CALIFORNIA COASTAL COMMISSION

STAFF REPORT: REGULAR CALENDAR 15.c.**APPLICATION NO.: 4-97-191****APPLICANT: Dr. John K. Kim AGENT: Richard Dodson, Architect****PROJECT LOCATION: 24300 Malibu Road, City of Malibu, Los Angeles County**

PROJECT DESCRIPTION: Demolish existing residence and garage. Construct a new 4,275 sq. ft., two story, single family residence with attached 440 sq. ft. two car garage, 246 sq. ft. storage loft; 1,366 sq. ft. of exterior decks, and new sewage disposal system. Construct new garden walls about 60 foot long, 3 1/2 foot high, along street, new driveway, new steps and landing platform to beach. Install 15 concrete caissons to support residence. Construct new wood bulkhead, 37 feet long with end wall, seaward of existing bulkhead, on western portion of parcel. Install base rock and overtopping rock blanket along 62 foot long existing wood bulkhead on eastern portion of parcel. Proposed grading includes 45 cubic yards of cut and 45 cubic yards of fill on site.

East Bulkhead
Elevation

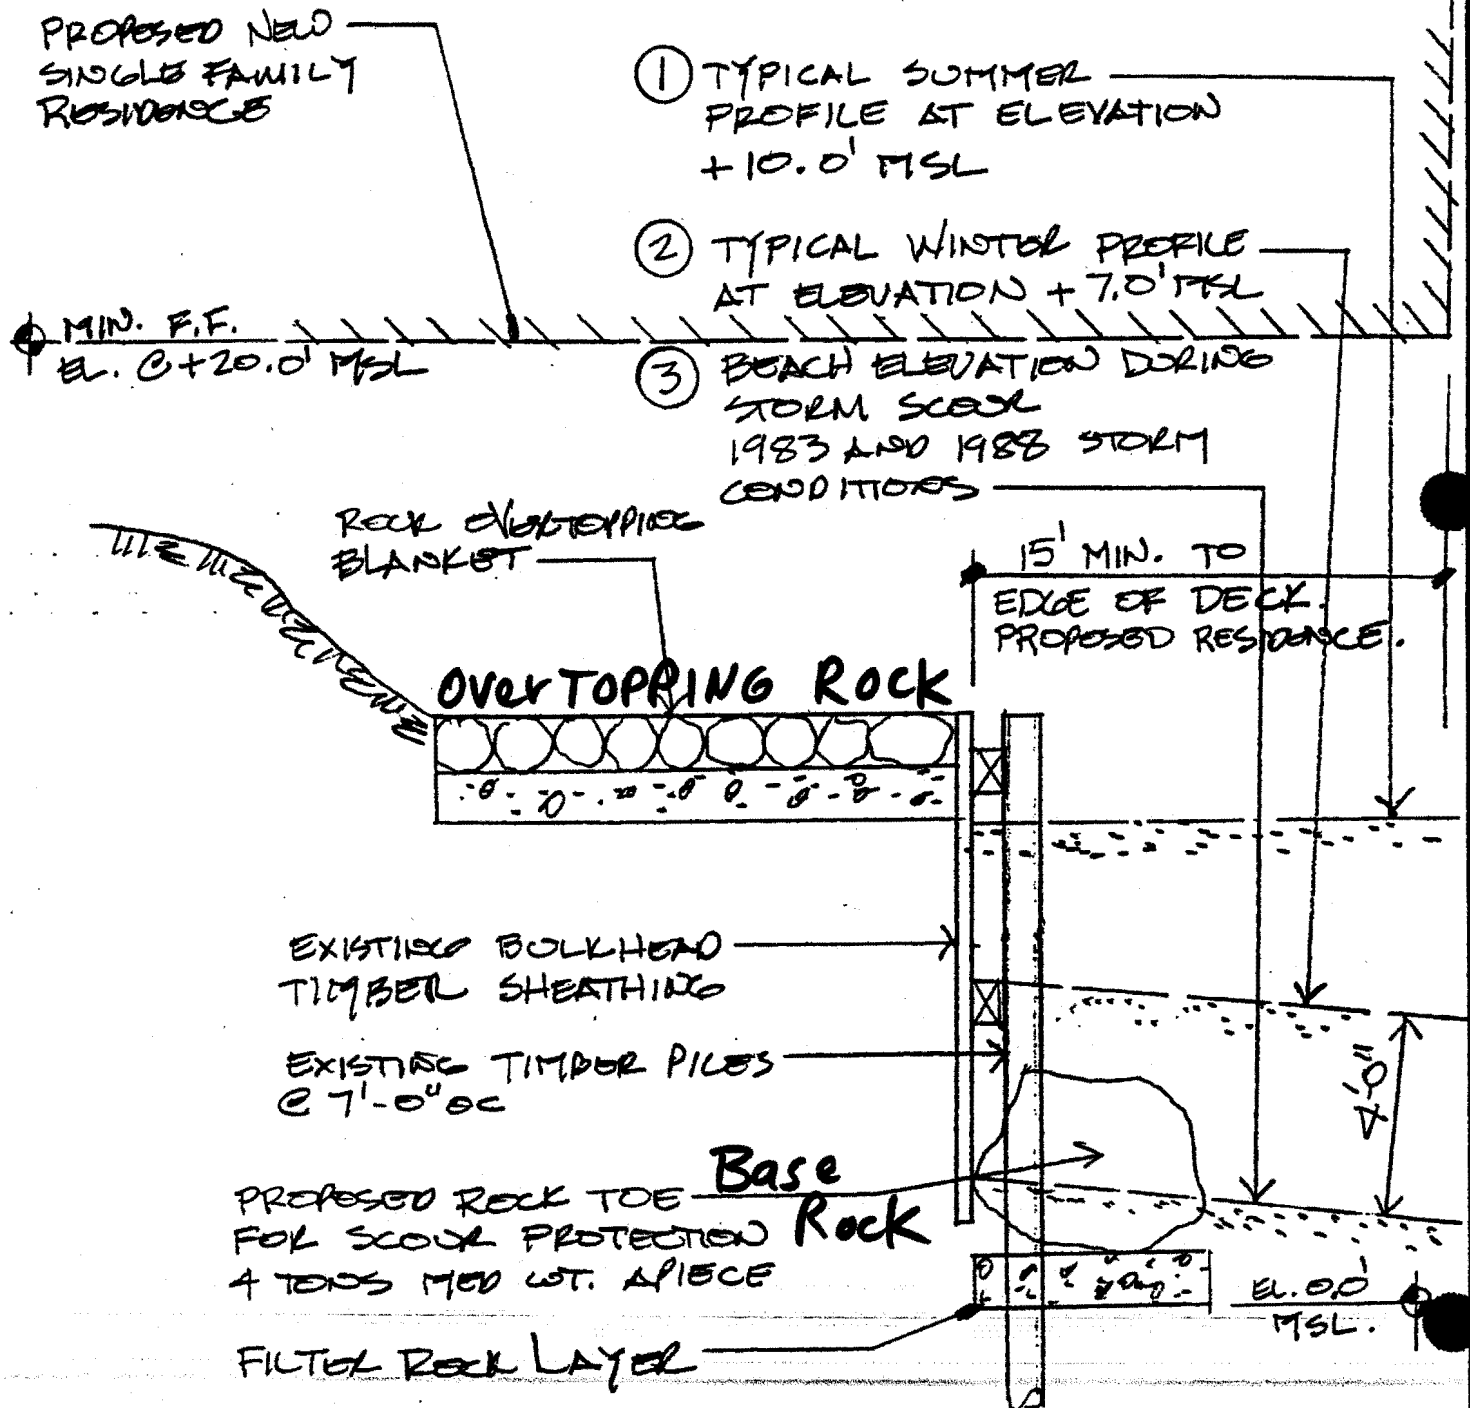
The proposed new 37 foot long wooden bulkhead and the 62 foot length of base rock along the existing bulkhead will be constructed on the sandy beach about 32 feet and 37 feet seaward of Malibu Road, respectively. An engineered bulkhead is typically built along straight sand beaches or low coastal bluffs where fill can be placed landward of the bulkhead to support roadways and other developments that are constructed on fill land. Therefore, the bulkhead structure functions as both a retaining structure and as protection from wave attack and wave runup.

The new residence proposed by the applicant will not encroach any further seaward than the existing residence. The applicant proposes to construct a shoreline protective device that encroaches further seaward. On the western portion of the property, a new wooden bulkhead is proposed to be located about seven (7) feet seaward across a 37 foot width. The encroachment area is 259 square feet of beach. On the eastern portion of the property, a row of base rock is proposed to be installed seaward of the existing bulkhead. This base rock placed on smaller filter rock will encroach about five (5) feet seaward across a 62 foot width. The encroachment area is 310 square feet of beach. Thus, the direct seaward encroachment impact of the applicant's proposed project will be a total of 569 square feet of sandy beach area.

The applicant initially proposed to retain the existing wooden bulkhead along the eastern portion of the property, however, the applicant's consulting engineer, Pacific Engineering Group, believed the existing eastern bulkhead was of questionable structural integrity. In the Pacific Engineering Group report dated April 30, 1997, the engineer stated:

There is an alternative to eliminate the seaward encroachment of the proposed base rock and reduce the seaward encroachment of the proposed western bulkhead. Replacing this eastern section of bulkhead with a new bulkhead in the same location, or further landward, which is deeper and higher will adequately protect the septic system and Malibu Road. Staff asked the applicant why this section of bulkhead was not proposed to be reconstructed rather than adding base rock and overtopping rock. The response provided in the Pacific Engineer Group update letter dated January 5, 1998, indicates the issue is one of economics.

Prior to issuance of coastal development permit, the applicant shall submit for the review and approval of the Executive Director, revised project plans relocating and redesigning the new bulkhead and septic system. The revised plans shall be prepared and signed by a licensed engineer(s) with expertise in designing shoreline protective devices and sewage disposal systems. The revised plans shall locate the proposed wooden bulkhead across the entire width of the parcel as far landward as feasible (which is approximately ten (10) feet landward of the existing eastern bulkhead) to accommodate a redesigned and relocated sewage disposal system. The revised plans shall: delete all proposed base rock; remove the entire existing bulkhead; and remove the portion of the end walls necessary to join them to the relocated new bulkhead. The revised plans shall include an adequate design to construct a replacement wooden bulkhead of appropriate depth and height in this new location, with revised connecting end walls on the west and east ends as appropriate which is generally depicted on Exhibit 14. The proposed septic system shall also be adequately re-designed by size, location, and type, as necessary, to be constructed adequately landward of the redesigned and relocated wooden bulkhead. The applicant shall submit evidence, for the review and approval of the Executive Director prior to the issuance of the coastal development permit, that the revised plans have been reviewed and approved by the City of Malibu Environmental Health Department.

this end wall extension will now be shorter to connect it to a new bulkhead located further landward. This proposed location will be located further landward of the bulkhead located on the adjacent property to the east (*Exhibit 14*). The precise location of the most landward location of the proposed bulkhead and the length of the two end walls will be determined after the septic system is redesigned as noted above and approved in concept by the City of Malibu Department of Environmental Health. Another option is for the adjoining property owner to remove the connecting bulkhead and construct an approximate five (5) foot length of bulkhead to complete a connection to the subject bulkhead, with the necessary permits. Such a connection would eliminate the need for the short length of connecting bulkhead angled seaward at about 45 degrees as it would no longer be necessary.
